LiDAR Quality Assessment Report

AR-FEMA_ChicotDesha_Lot2-2012

FEMA VI - Chicot & Desha Lidar

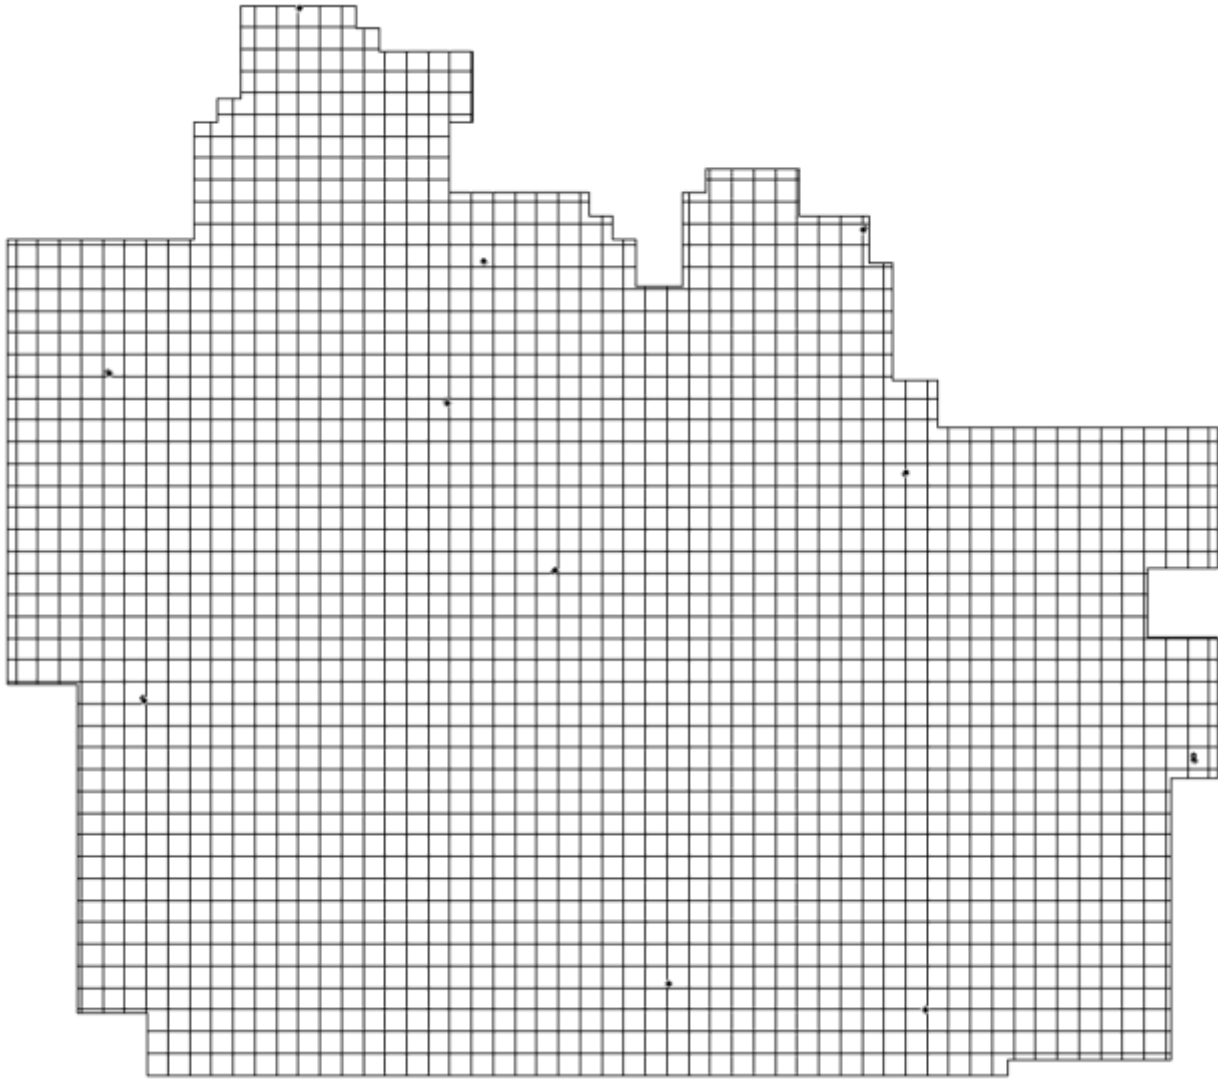
Test Points Clustered Which is acceptable but improperly selected, ie, there is no Urban and they have 20 points. Also Bare Earth Labeled FVA.

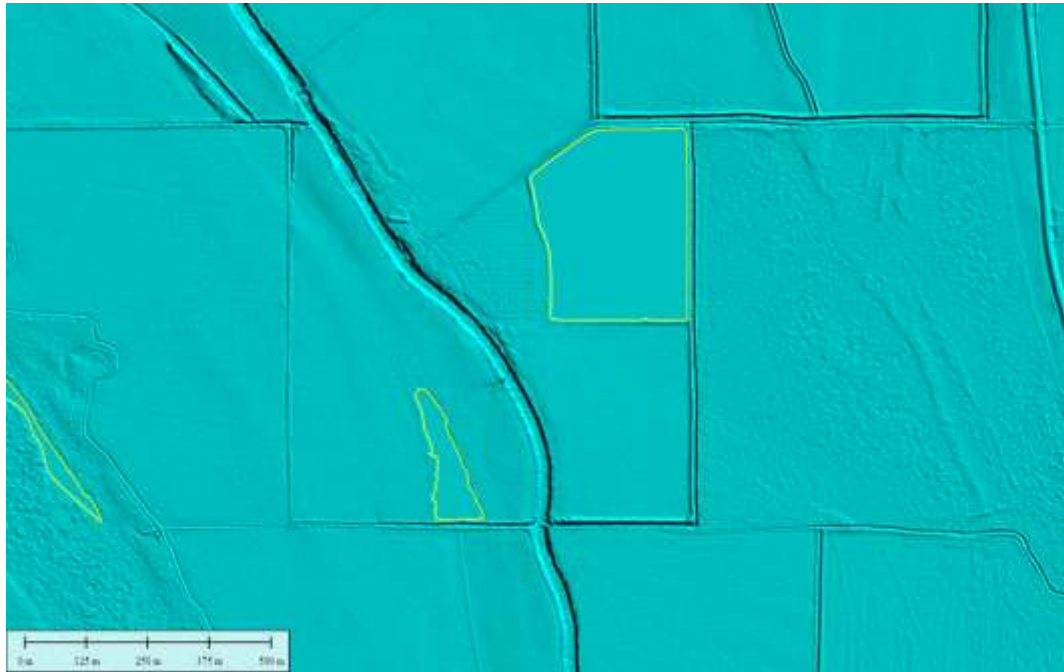
Flooded Fields: This is a representative example of hydroflattened fields (with breaklines); these occur throughout the project. These are not flagged as errors. The "flattened" fields suggest they were inundated at the time of lidar collection.
